Gill Engineering Services, Inc.

**Structural Audit
Repair Recommendations
Lake City, FL**

BRINKLEY REPAIRS

Insufficient Wall Footing (BW1)

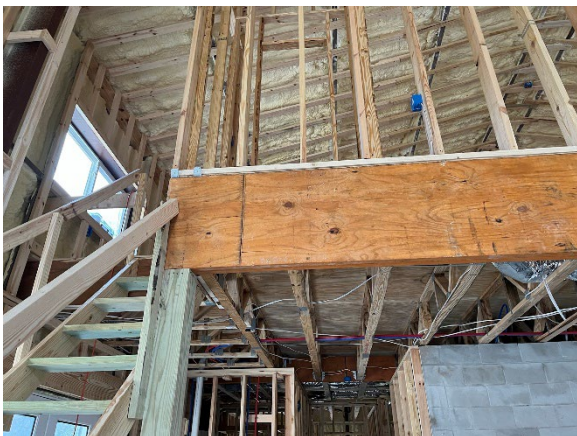
1. Bearing wall referenced "BW1" requires an interior footer as noted on the permitted plans. Client drilled a hole through the concrete adjacent to the demonstrate an average slab depth of 4". The plans require a minimum depth of 12" under the wall.

A new 12" deep x 12" wide footing is required under the full length of the wall. Temporarily support the attached floor trusses and remove the current wood framed wall. Saw cut and remove slab. Pour new interior footing as shown on Detail 2 Sheet S-301 of permitted drawings.

Unsupported CMU walls (BW3, BW4, and C3)

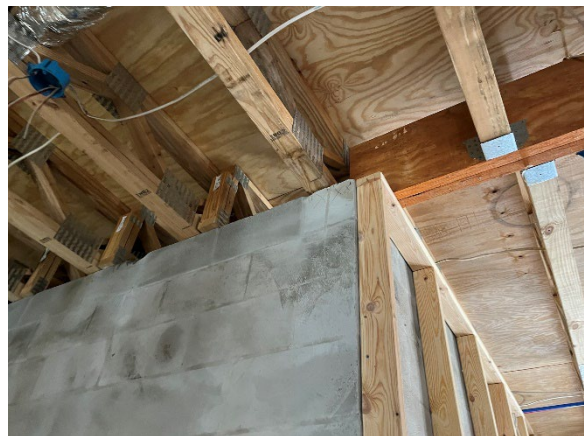
5. Bearing walls BW3, BW4, BW5, and C3 require interior footings. The plans call for the walls to be wood framed. The constructed walls are 8" CMU fully grouted.

- (a) Temporary support floor trusses as needed and remove existing CMU wall. Saw cut floor and pour new interior footing for bearing wall. Refer to SK-002 for suggested footing size and reinforcing.
- (b) Underpin the bearing walls BW3, BW4, and BW5. Refer to a Foundation Underpinning Contractor for guidance.

2
S-301
INTERIOR FOOTER DETAIL
SCALE: 1/8" = 1'

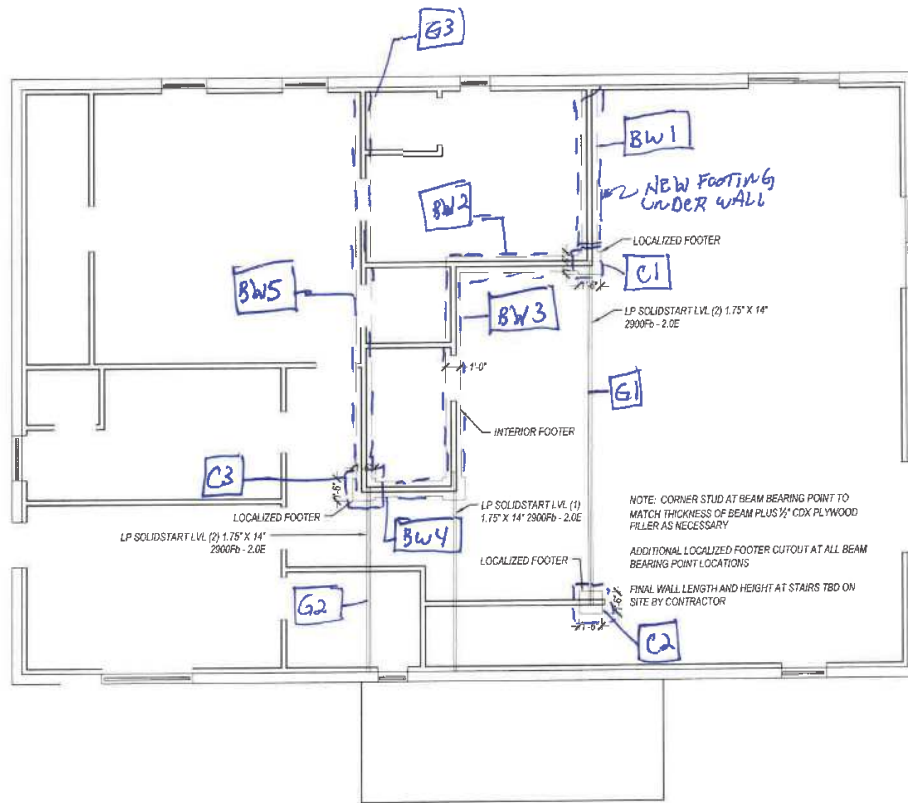
As stated by client, the concrete floor was poured without interior wall or columns footings. The permitted drawings require interior bearing wall and column footings. Listed below are structural items that needs addressing. Refer to marked up "Interior Footer and Beam Plan" for wall, beams, and column designation.

2. Column reference "C1" does not have an adequate footing and support post.

3. Column reference "C2" does not have an adequate footing and support post.

4. Bearing wall referenced "BW2" requires interior footing as detailed on plans.

24" LVL BEAM SUPPORT

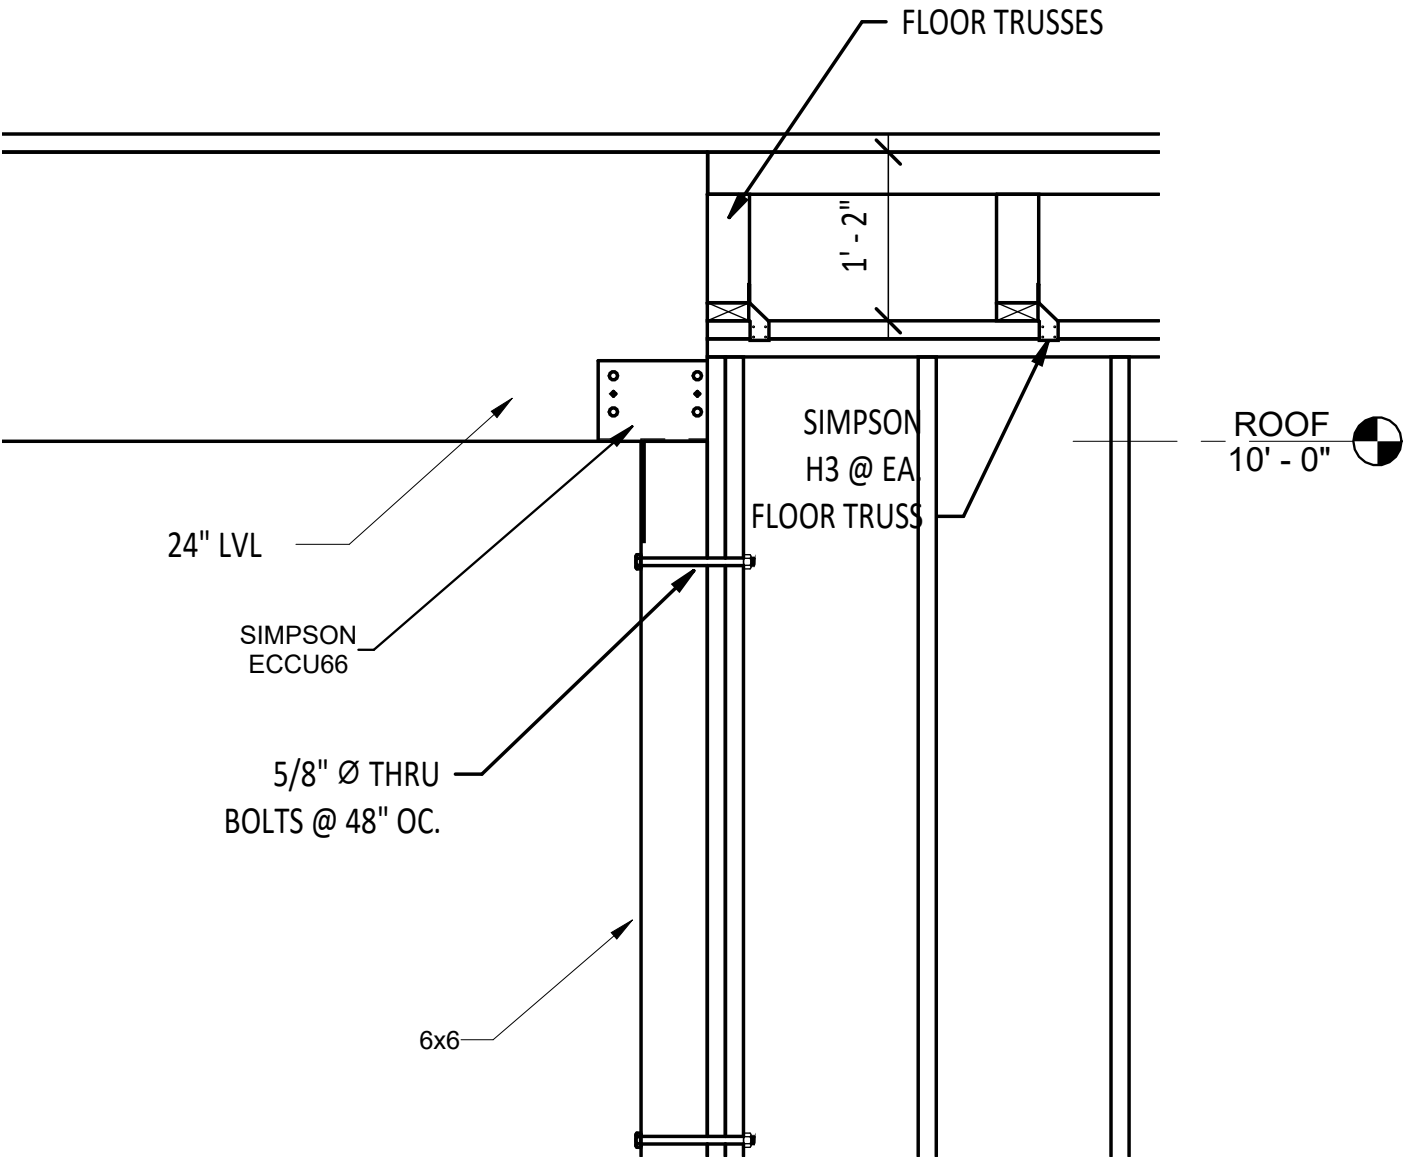
1. The 24" LVL Girder (G1) has been notched at the member end. The notch has compromised the load capacity of the girder. The span will require shortening and re-supporting

The notch needs to be removed. Shorten the length of the beam and support with new column. Refer to Repair sketch detail S-003

WALL REINFORCEMENT

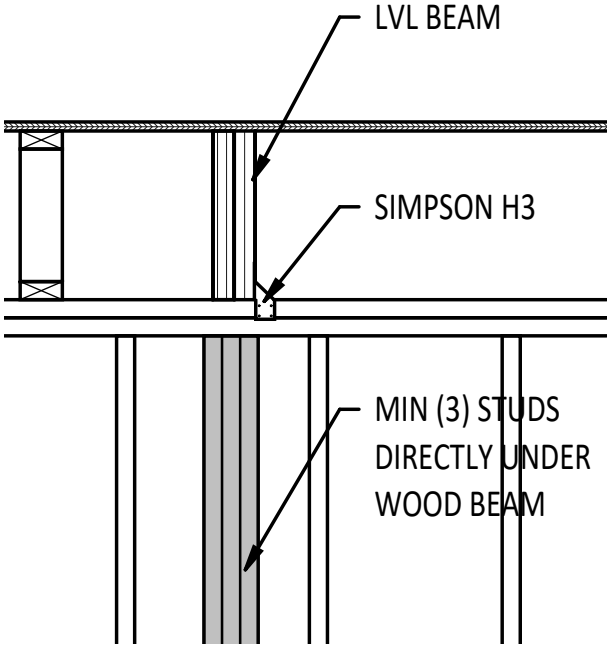
3. Owner to verify the (2) ply 14" LVL bearing on the CMU wall is pressure treated. If not, separation between the two is required.
4. The LVL ends bearing on the exterior wall (wood framed) requires jack studs directly under the LVL beam.

Add additional 2x studs under LVL beam. Refer to Sketch S-004
